## DEVELOPMENT APPLICATION ASSESSMENT REPORT

<b>Application Number:</b>	DA2019/1395
----------------------------	-------------

<b>Responsible Officer:</b>	Catriona Shirley
<b>Land to be developed (Address):</b>	Lot 36 DP 25164, 45 Earl Street BEACON HILL NSW 2100
<b>Proposed Development:</b>	Alterations and additions to a Dwelling house
<b>Zoning:</b>	Warringah LEP2011 - Land zoned R2 Low Density Residential
<b>Development Permissible:</b>	Yes
<b>Existing Use Rights:</b>	No
<b>Consent Authority:</b>	Northern Beaches Council
<b>Land and Environment Court Action:</b>	No
<b>Owner:</b>	Peter Joseph Conduit
<b>Applicant:</b>	Rapid Plans Pty Ltd

**Figure 1.** Non-compliant wall height on the western elevation shown in green.

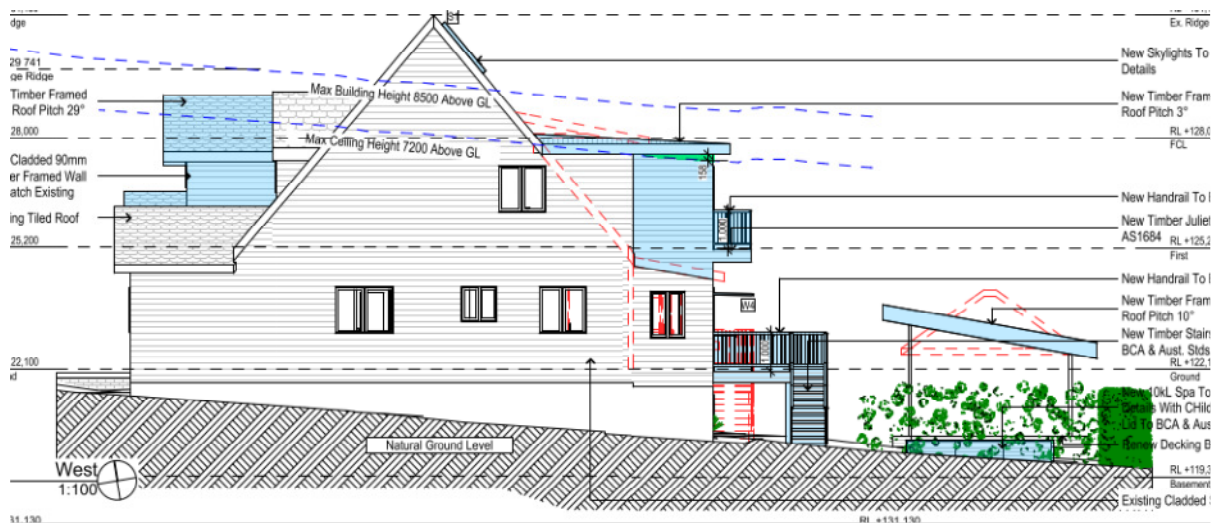
The development proposes a wall height of between 7.2m and 7.3m on the western elevation, see Figure 1.

The non-compliance corresponds with the slope of the site and the siting of the existing house.

The extent of the non-compliance up to (0.1m) is considered to be minor when compared to a compliant wall height, and a compliant wall height would not result in any notable improvement to the overall visual appearance of the development.

Notwithstanding, because of the minor nature of the breach and that it does not extend for the full length of the side wall, the non-compliance does not unreasonably offend the visual appearance of the development by resulting in an unreasonable bulk and scale when viewed from adjoining properties and streets.

Having regard to the above assessment, it is concluded that the proposed development is consistent with the aims and objectives of WLEP 2011, WDCP and the objectives specified in s1.3 of the Environmental Planning and Assessment Act, 1979. Accordingly, this assessment finds that the proposal is supported, in this particular circumstance.

**Figure 2.** Eastern building envelope non-compliance shown in green.

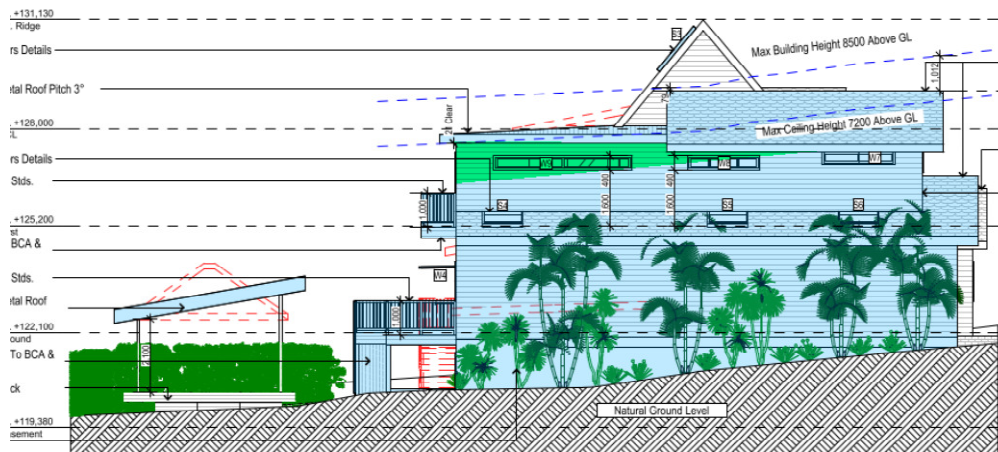
The non-compliant areas occur along the eastern and western side elevations demonstrated in Figure 2 and 3 below.

The breach to the eastern side is not as noticeable due to a smaller variation and the prevalence of the larger side setback.

**Figure 3.** Building envelope non-compliance for the existing building shown in pink and the additional non-compliance shown in green.

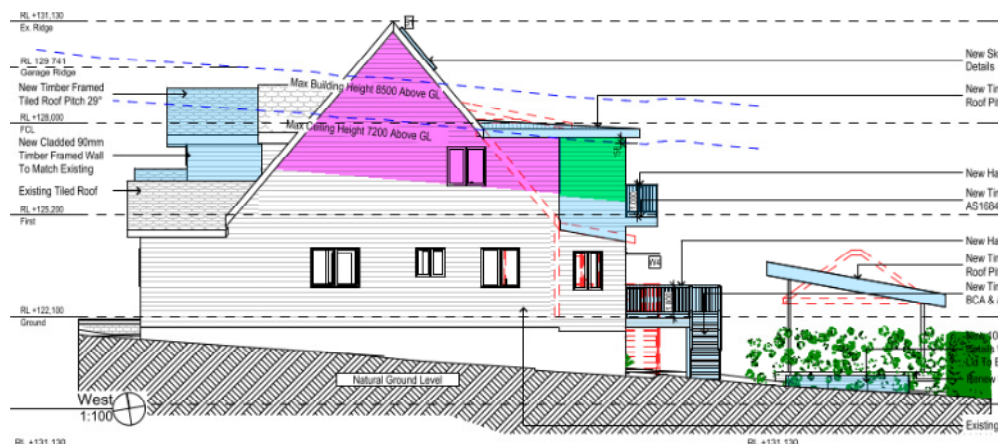
It is noted by comparison with the existing built form that the building already included a level of noncompliance to the western side boundary envelope as demonstrated in Figure 3.

The development increases the level of non-compliance of the western side wall due to the new extension to the first floor.

Due to the presence of existing walls, the breach to the building envelope most notably occurs at the south-east and south-west corner of the building where the slope of the site is most acute and the existing floor levels of the dwelling are sited 1.4m above natural ground level.

**Figure 4.** Rear setback area shown in pink, portion of the rear setback area containing the swim spa and cabana shown in green.

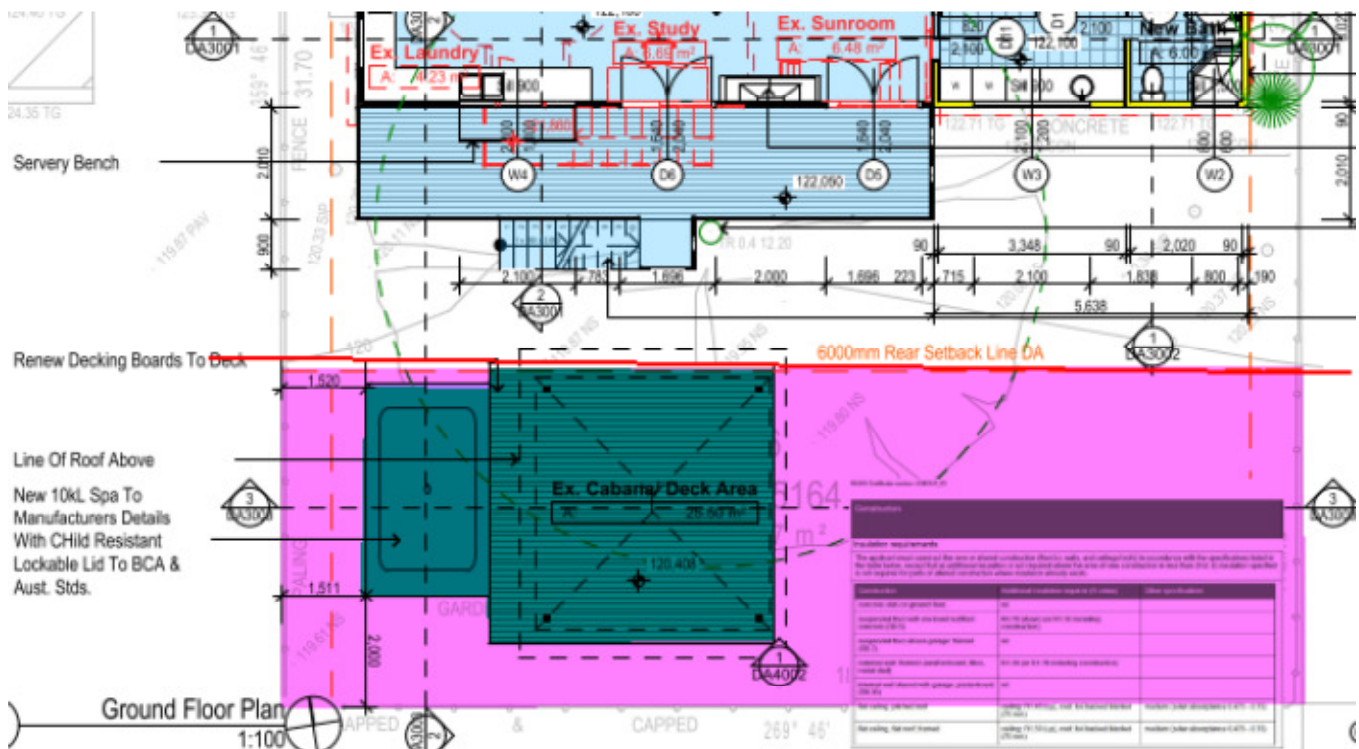
The proposal has located a swim spa, deck and associated roof within the rear setback.

The swim spa and decking makes up 30% of the total rear setback area as shown in figure 4 below. Therefore, the proposal complies with the DCP requirement that such ancillary structures to a dwelling *"must not exceed 50% of the rear setback area"*.

However, a condition will be applied to require the decked area and associated roofing to be located a minimum of 2m from the rear setback to ensure the objectives of the rear setback are met.

The conditioned distance of 2m from the rear setback for the swim spa, and decked area will allow additional area for deep soil landscaping to provide vegetative privacy screening.
